# HISTORIC DISTRICT COMMISSION

# CERTIFICATE OF APPROPRIATENESS

**Application Number: HDC2025-00129**

Project Address: 863 Iroquois

House 7.5Ft Stide Walk

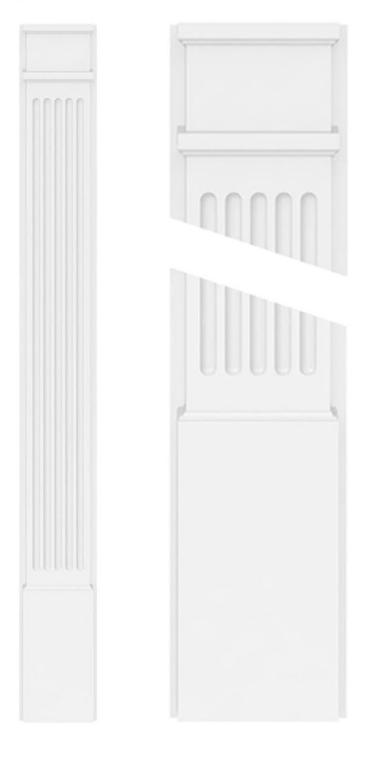
6/02 - Concrete driveway –a site plan (hand drawn is fine) with dimensions of existing/proposed driveway footprint noted is necessary.

8/28 – the mocked-up photo is helpful, but we still need to receive a dimensioned footprint/site plan that states the overall dimensions and clearly shows where the driveway will begin and end.

proposed driveway replacement will be 93x 7.5ft extending from the back edge of the house to the city sidewalk. it will not include city sidewalk and below. see attached photos.

TruCraft Fluted Pilaster w/Decorative Capital & Base, 12"W x 120"H x 2"P Base Can Be Trimmed Up to 6 5/8", Architectural Grade PVC, Sold As Pair

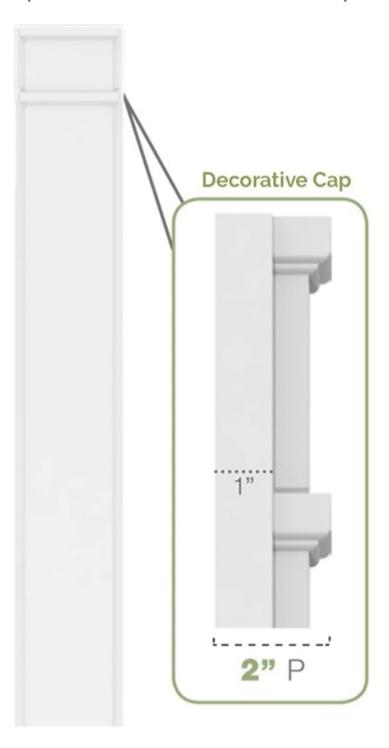
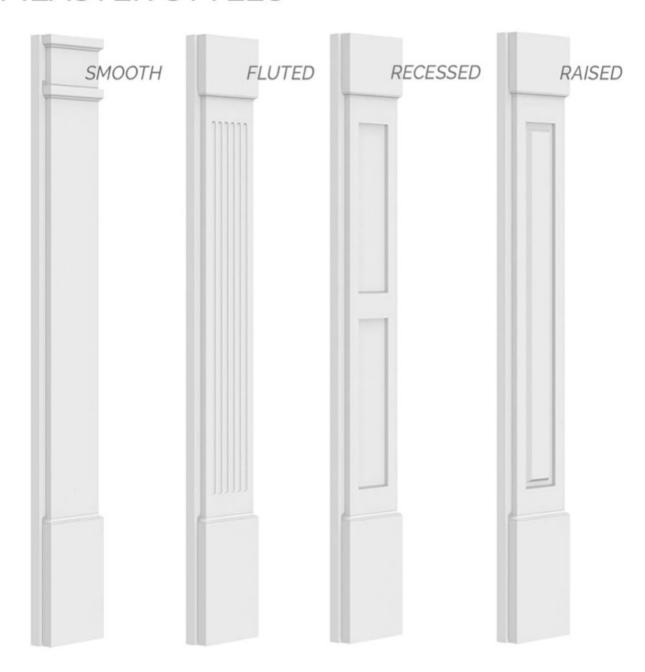
It appears the outside square column has been replaced in violation. The new column design does not match the historic column design. Staff does not have authority to approve this replacement column.

There are 4 pilasters that make up the outside columns on the front corners of the house. these were in significant decay and were replaced in violation. I sincerely apologize for this. I have attached a proposed for replacement of the original pilasters (12 inches in width x 25ft Length x 2inch depth) see attached cut sheet (Fluted column).

# Porch Center Column Existing.

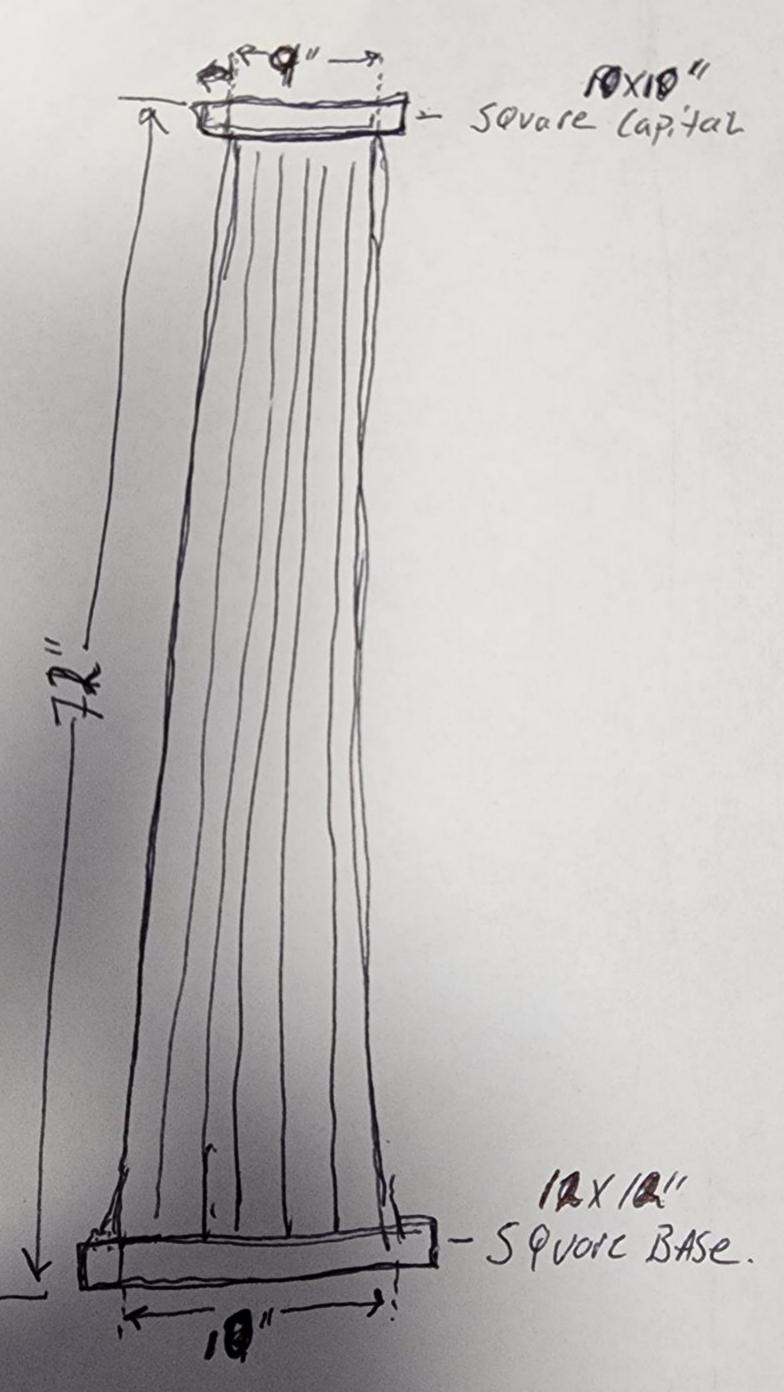
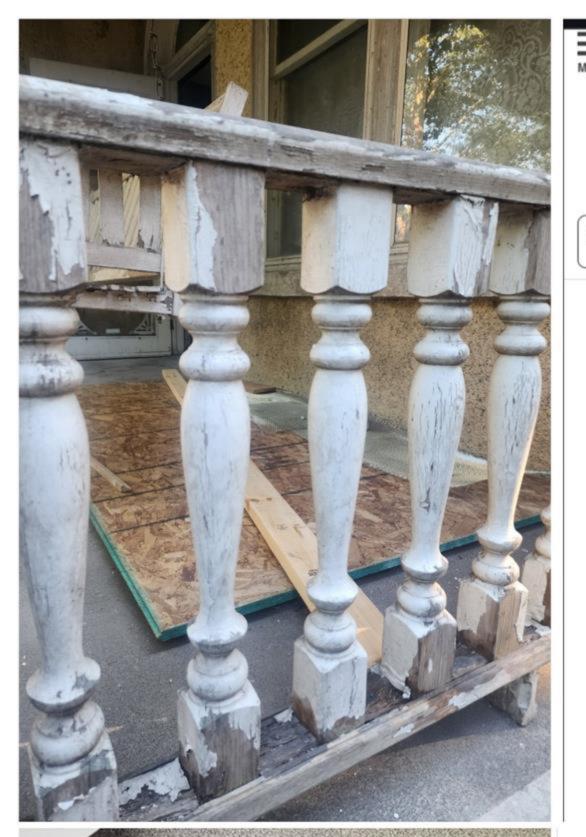
8/28 – Staff doesn't have authority to approve replacement columns, except for the central column that is partially missing. As stated above, dimensions of the existing column (width of shaft, and base and capitol detailing) are needed, as well as the cut sheet for the proposed column that shows the design and all dimensions, material and finish, are required for review.

The central column on the porch is 6ft in height, tapered and fluted with a 9 inch diameter at the top and a 10 inch diameter at the base. it has a 10 inch Tuscan capitol and a 12 inch Tuscan base. the proposed central column has identical dimensions and will be finished in white to match the existing trim.
